CLAREMONT BUSINESS PARK 2 FILING NO. 2

CONSTRUCTION PLANS

JUNE 2023

V2_Construction Drawings.pdf Markup Summary

CLAREMONT BUSINESS PARK 2 FIL. NO. 2
STREET IMPROVEMENT PLAN

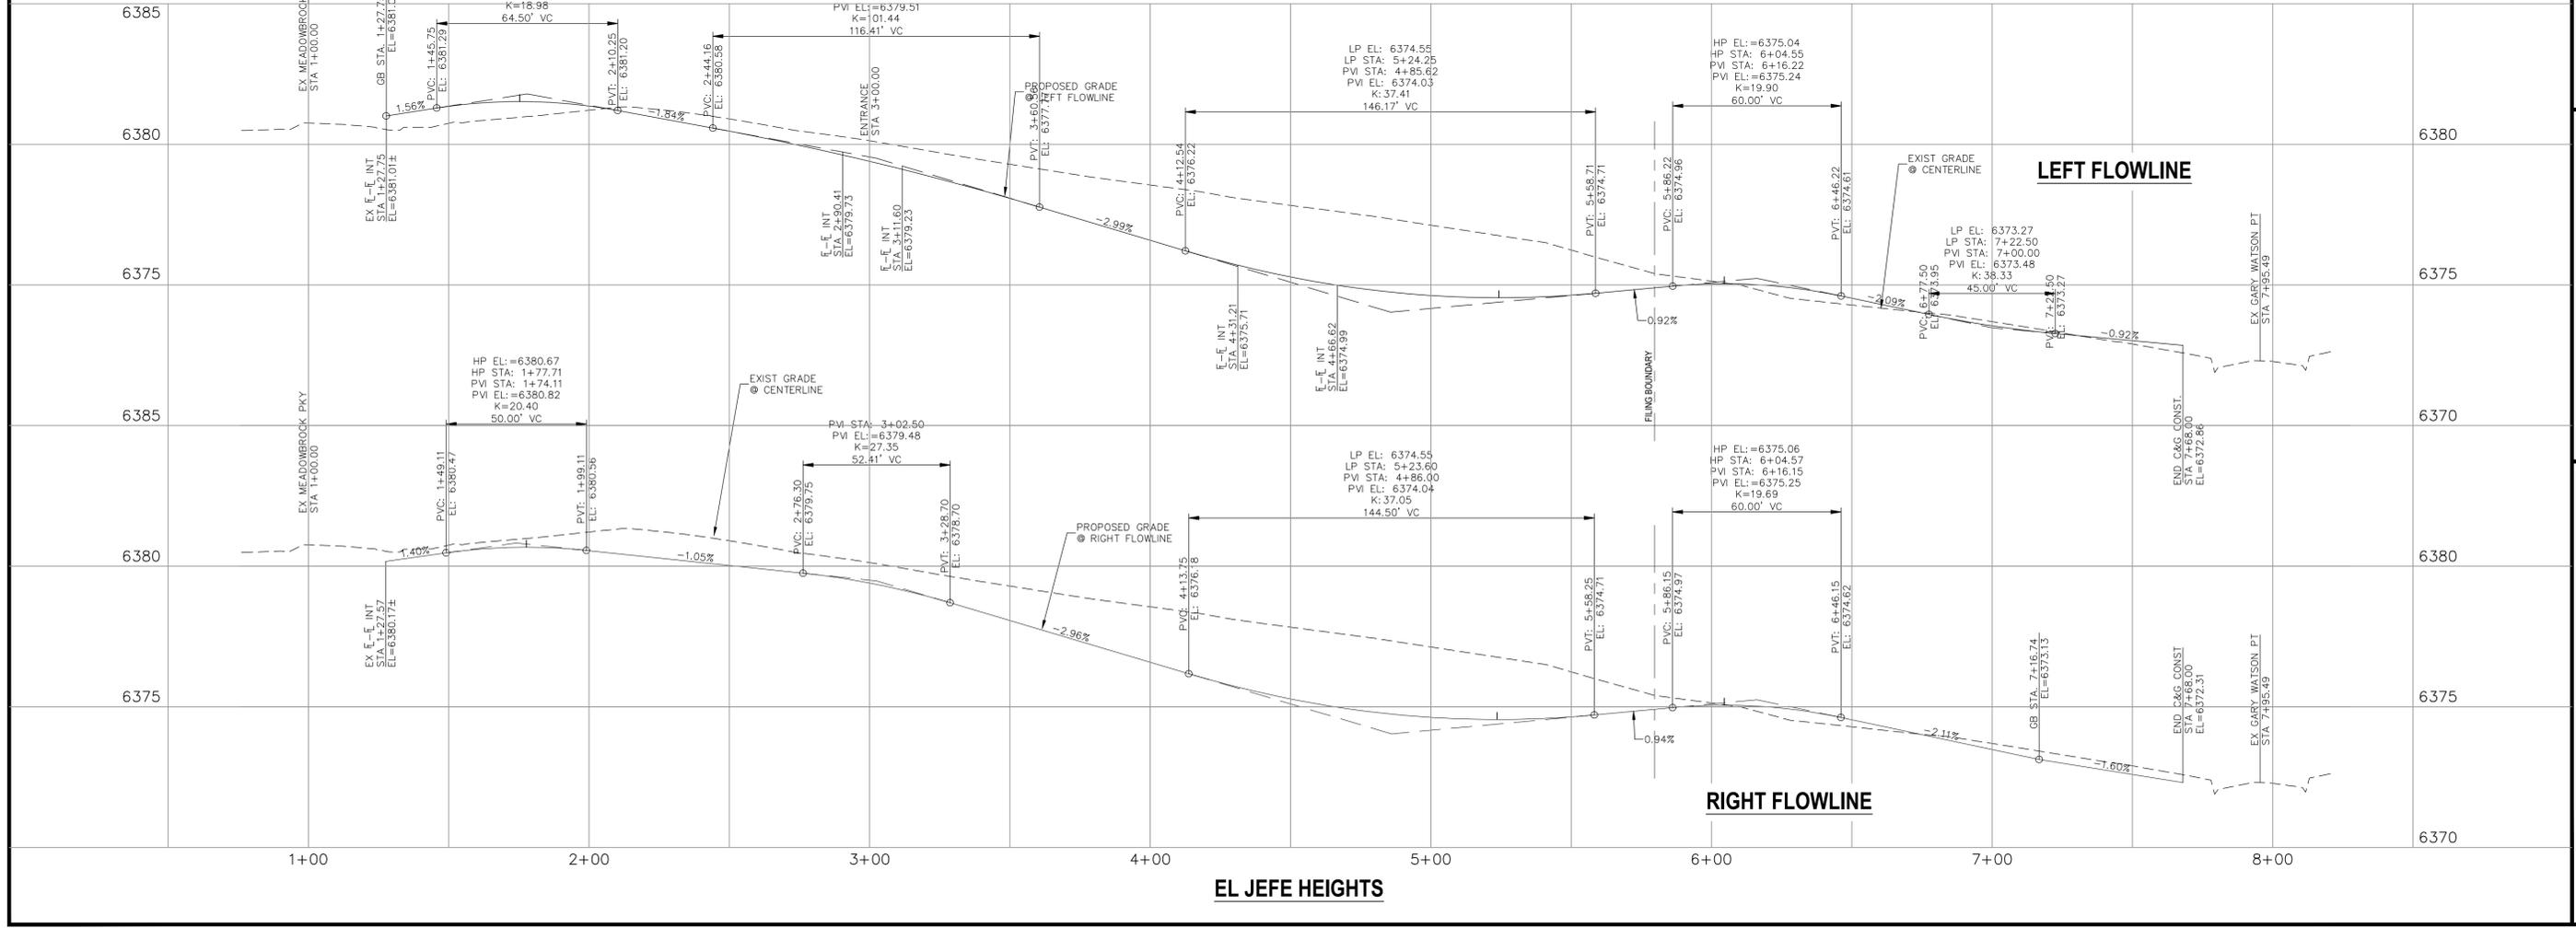
Label this line or turn off.

**CDOT TYPE C
WATER QUALITY OUTLET BOX AND SAND FILTER
SECTION A-A
NOT TO SCALE**

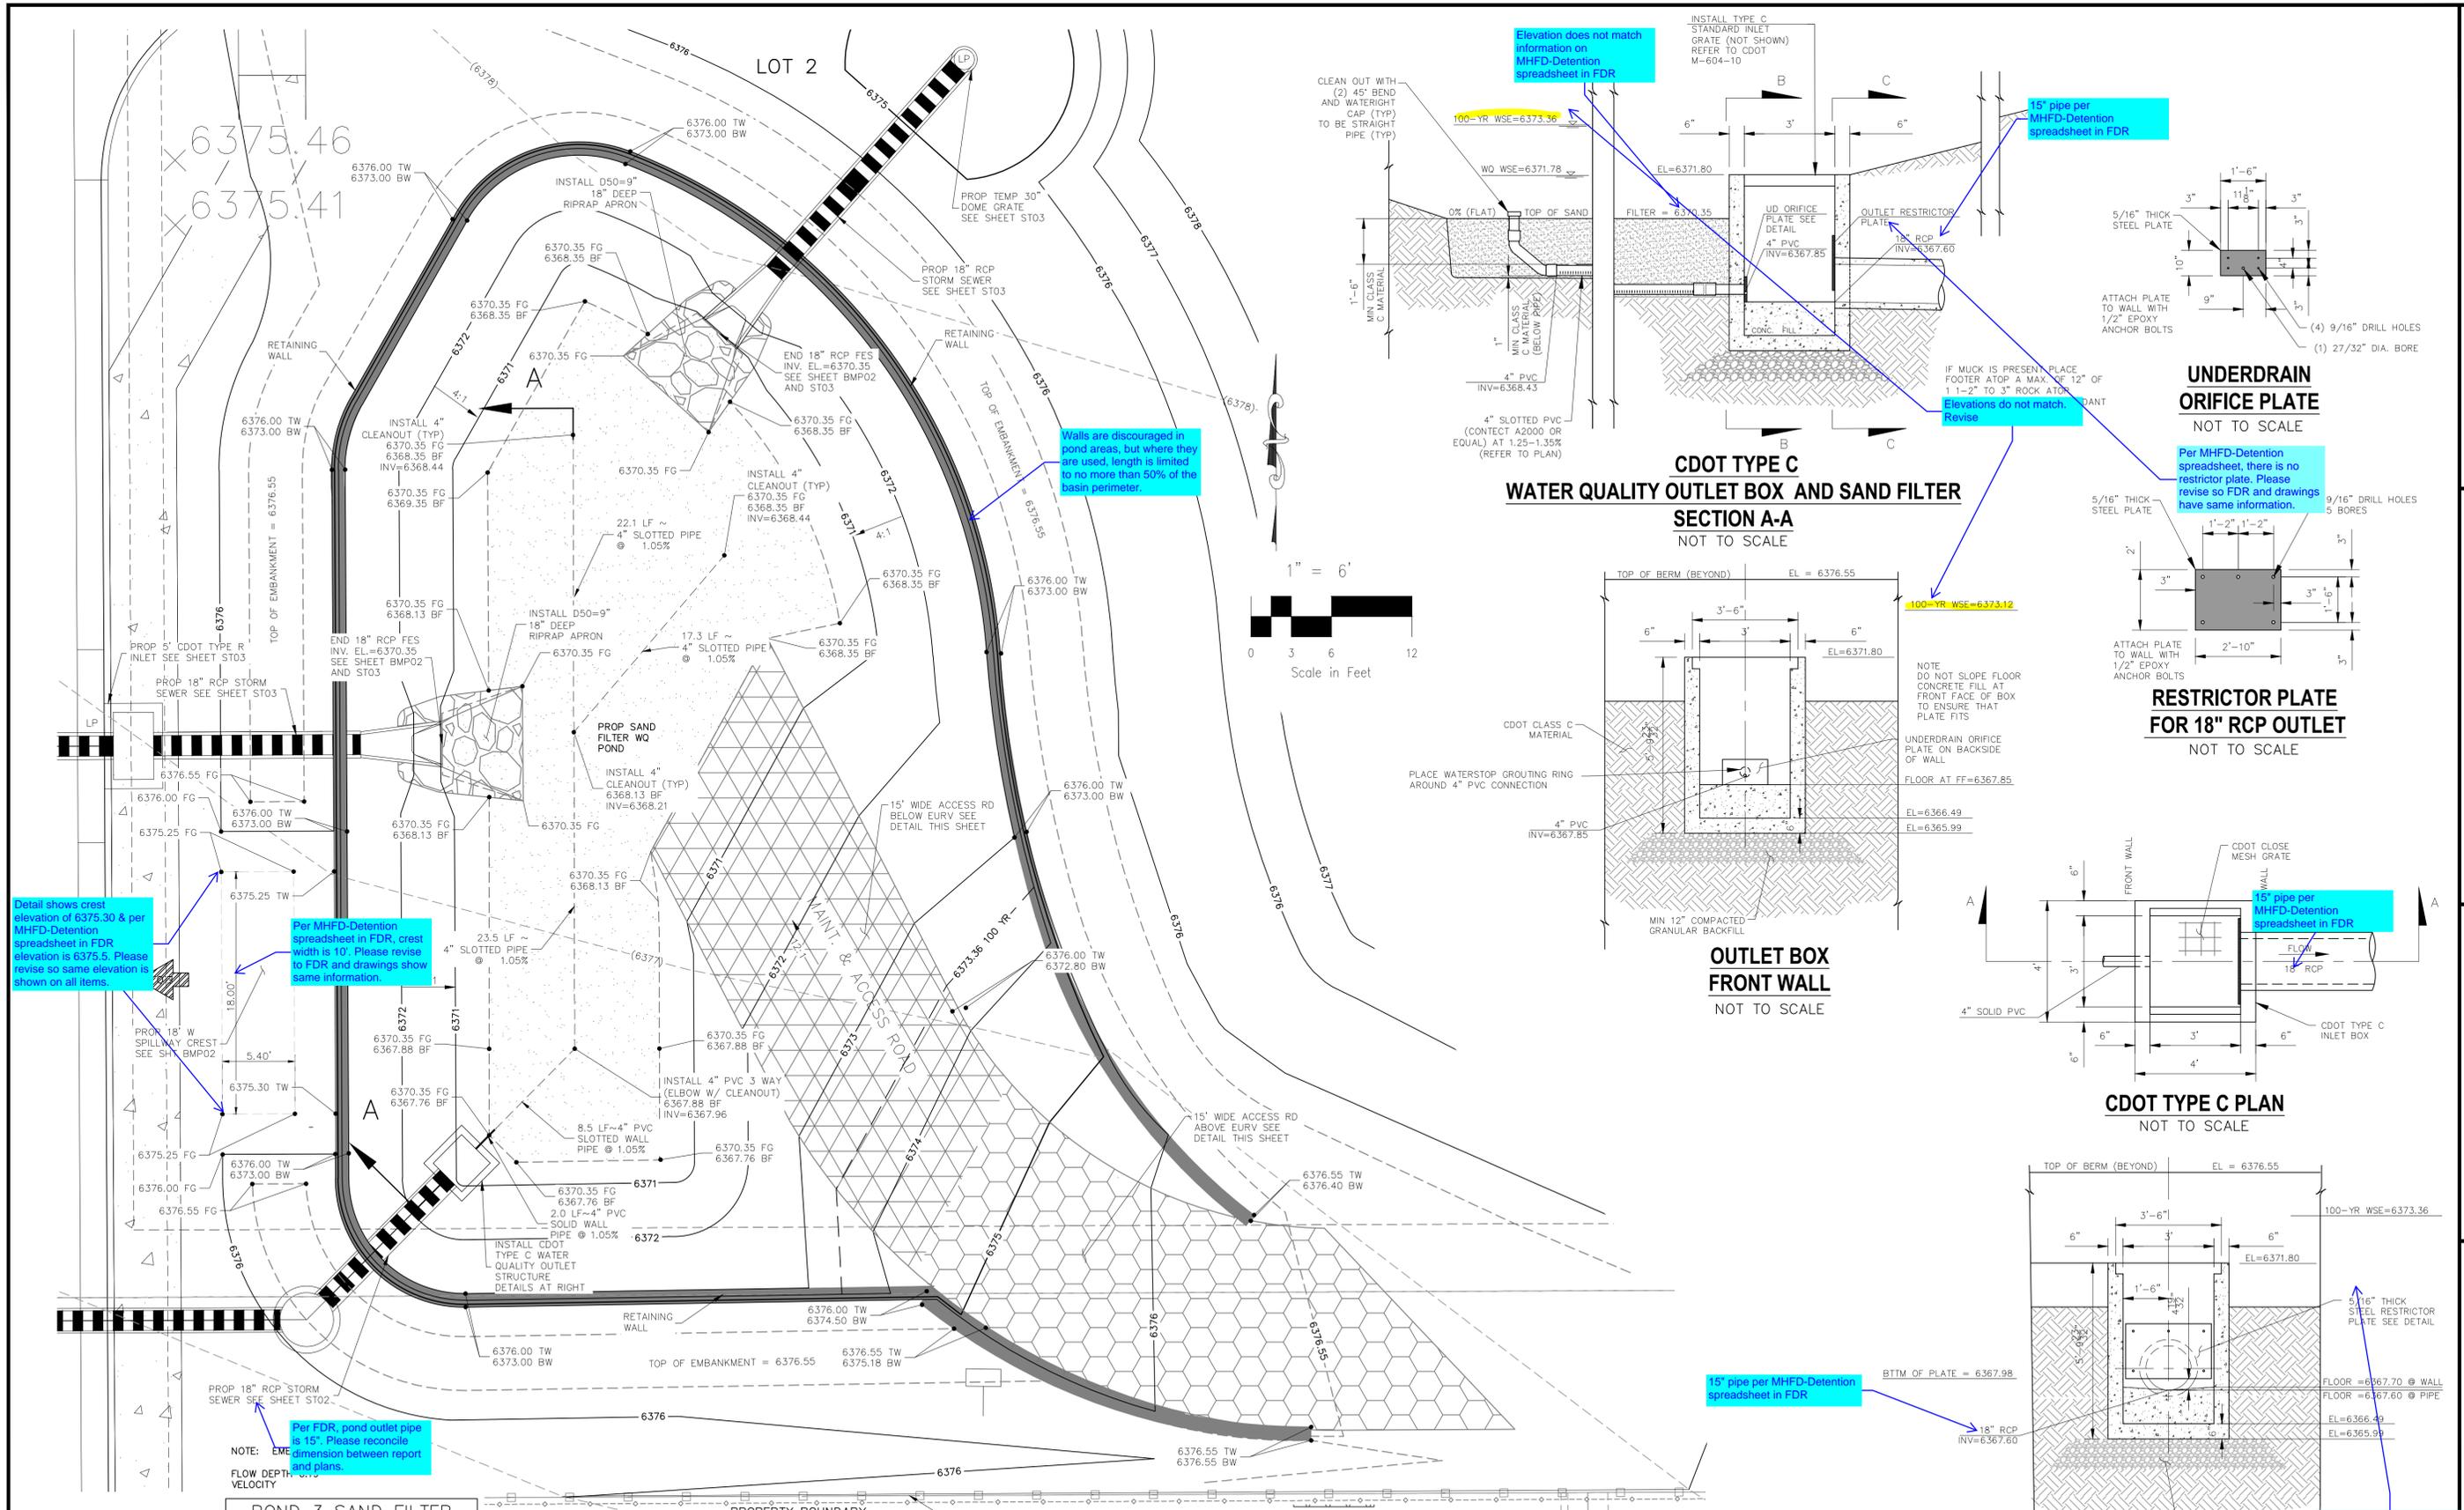
Detail shows crest elevation of 6375.30 & per MHFD-Detention spreadsheet in FDR elevation is 6375.5. Please revise so same elevation is shown on all items.

Per MHFD-Detention spreadsheet in FDR, crest width is 10'. Please revise to FDR and drawings show same information.

Per FDR, pond outlet pipe is 15". Please reconcile dimension between report and plans.

Walls are discouraged in pond areas, but where they are used, length is limited to no more than 50% of the basin perimeter.

Elevation does not match information on MHFD-Detention spreadsheet in FDR

15" pipe per MHFD-Detention spreadsheet in FDR

Elevations do not match. Revise

**RESTRICTOR PLATE FOR 18" RCP OUTLET
NOT TO SCALE**

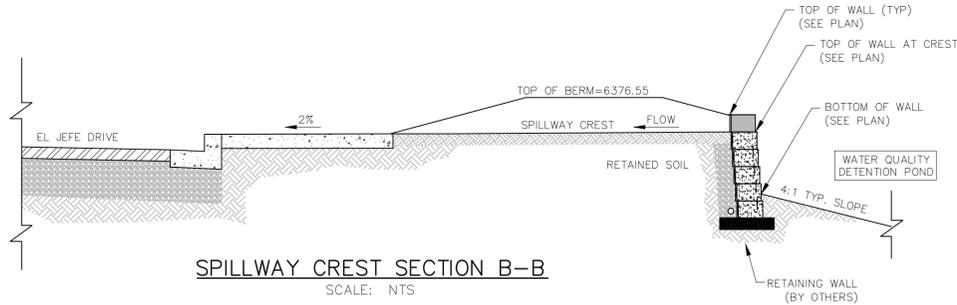
Per MHFD-Detention spreadsheet, there is no restrictor plate. Please revise so FDR and drawings have same information.

15" pipe per MHFD-Detention spreadsheet in FDR

Per MHFD-Detention spreadsheet, there is no restrictor plate. Please revise so FDR and drawings have same information.

SPILLWAY CREST SECTION A-A
SCALE: NTS

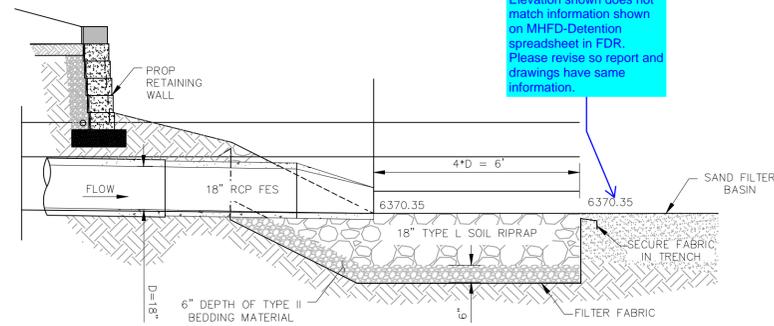
10' per mHFD-Detention spreadsheet in FDR

18" RCP RIPRAP APRON
SECTION C-C
SCALE: NTS

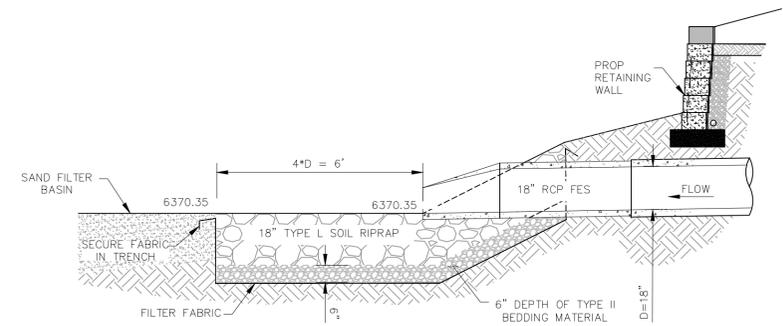
Elevation shown does not match information shown on MHFD-Detention spreadsheet in FDR. Please revise so report and drawings have same information.
